PLANNING COMMISSION MEETING AGENDA
JANUARY 23, 2019

3.1. (CUP-18-012) Action on a request by YIP Cottonwood LLC for a 149-room hotel located at 7365 S Canyon Centre Parkway.

Planning Commission Staff Report
Meeting Date: January 23, 2018

**FILE NUMBER/
PROJECT NAME:** CUP-18-012 – Courtyard by Marriott Hotel at Canyon Centre

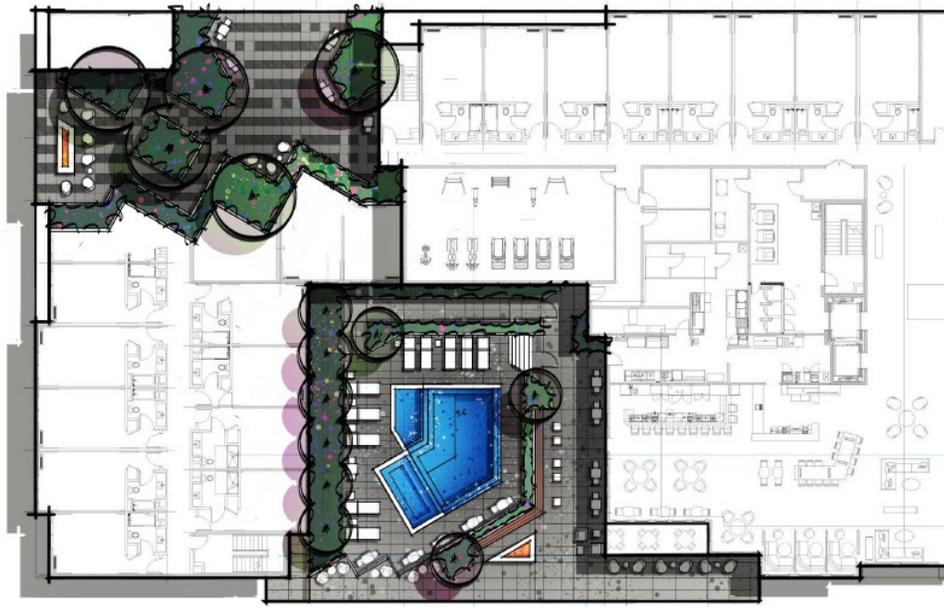
By default, the MU zone allows for two stories, but the proposal has four building levels for human occupancy. The following height graphic was approved as part of the Master Site Plan approval and establishes the allowable maximum building heights for the project.

The following ordinances were applied at the time of the master site plan approval to allow the building to be built as proposed:

1. **Determination of Natural Grade.** The code measures height from the natural grade. This location was established as part of the previously approved site master plan (see 19.76.030.D).

2. **Stories Are Above Natural Grade.** The code does not consider building levels that are below natural grade as story “for the purposes of measuring maximum building height (see 19.76.030.I).” Under that provision, the first level of the hotel is not a story.

3. **MU Zone Third Story Exception.** The MU zone typically limits buildings to two stories but allows for the expansion to a third story “upon a finding that such increased height will not adversely affect the public health, safety, or welfare (see 19.36.050).”

4. **The Gateway Overlay District Total Height Limit.** The Gateway Overlay Zone allows an overall building height of 45 feet (see 19.49.070.G.1). The average height for all buildings on the parking structure complies with this provision, as approved by the original site development master plan.

5. **Parapets Not a Part of Height.** Roof structures that screen utilities “may be erected above the height limits prescribed in this title when approved by the planning commission.” The parapets assist walls assist in the screening and housing of equipment and create a safety wall for any persons maintaining equipment or roofing areas (see 19.76.030.G).
